Response to WSCC comments December 2017.

SUBJECT: LU/278/17/RES - Approval of Reserved Matters following Outline Permission LU/47/11 for Construction of the southern section of the Lyminster Bypass, including northern and southern roundabouts, surface water drainage and landscaping. Departure from the Development Plan & affects a Public Right of Way.

LOCATION: North Littlehampton Strategic Development Site, Land West of Toddington Park, Toddington Lane, Littlehampton, BN17 7PP.

MB Drawing A/PHLYM.1/TR-2/P4 Worthing Road Roundabout Tree Removal

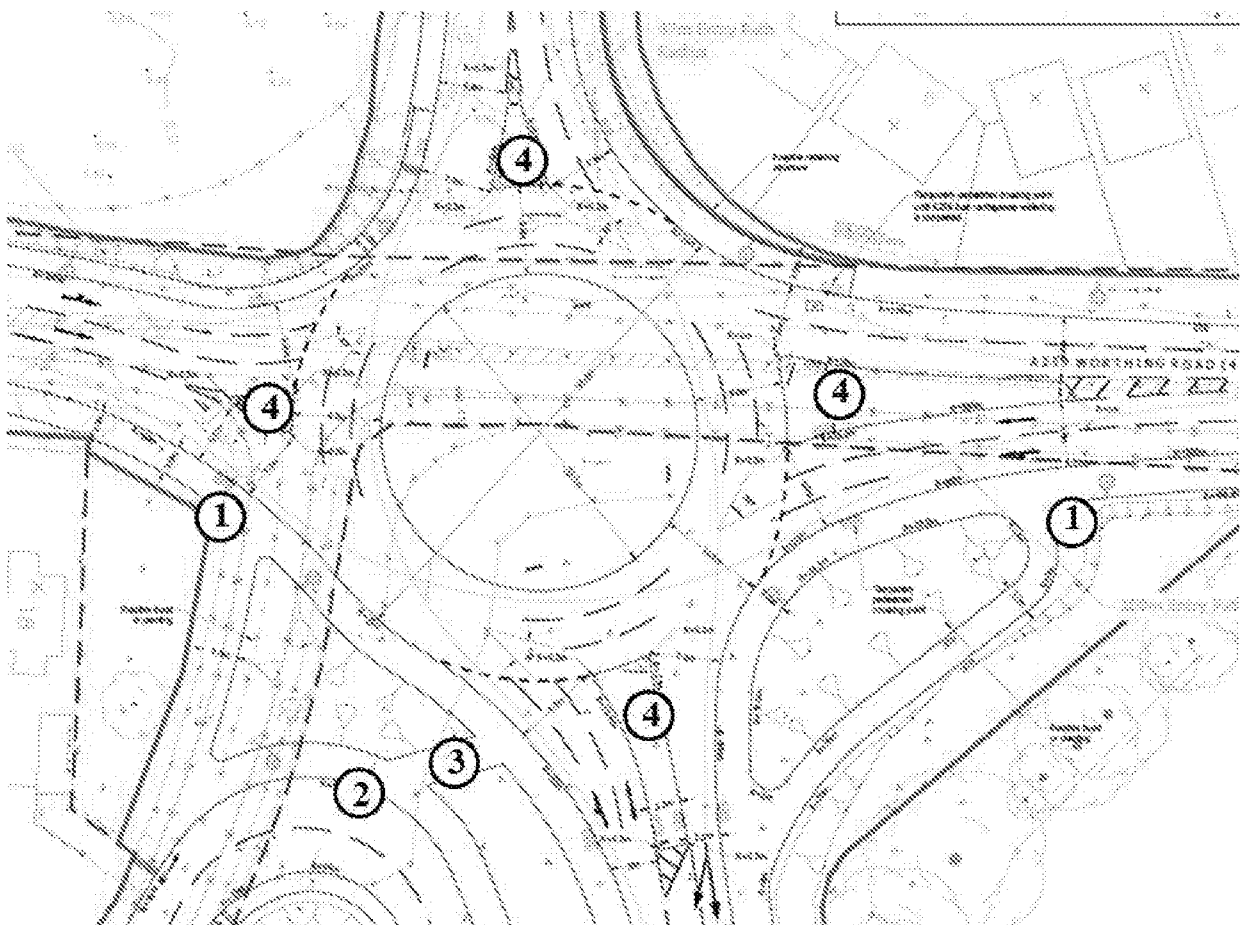
SEE LANDSCAPING COMMENTS.
